SI B13 07 12
Fuel Systems

This Service Information bulletin supersedes SI B13 07 12 **dated May 2013**.

N63 and S63 Engine: High-pressure Fuel Injector Replacement Procedures

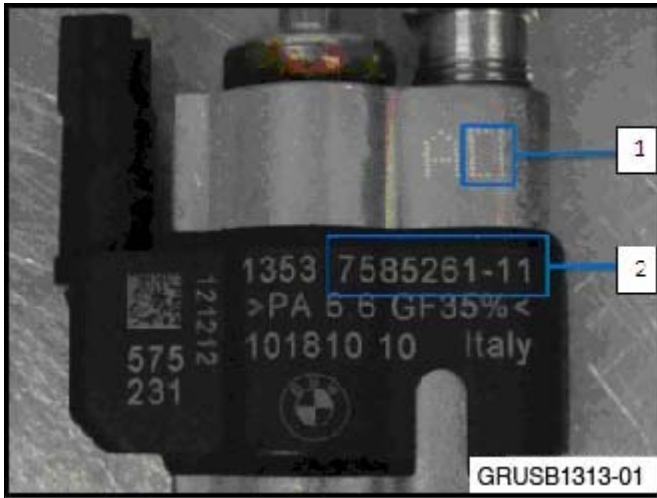
Additional Information: As of January 2013, an improved injector is available. Two distinct
--

markings on the injector itself will identify the improved injector.

1 = Internal material improvement

2 = 7585261 – (index) 11 or greater

The injector improvements consist of an internal filter and optimized thermal compensating oil.

IMPORTANT: Injectors with index 11 and higher have a different calibration and construction than injectors with index 10 and lower.

Due to this difference, the injectors with index 11 and higher and injectors with index 10 and lower cannot be mixed on the same engine bank (i.e., cylinders 1-4 or 5-8).

Once a bank of injectors is at index 11 or higher, the “bank set replacement” requirement no longer applies. For index 11 injector failures, only replace the failed injector.
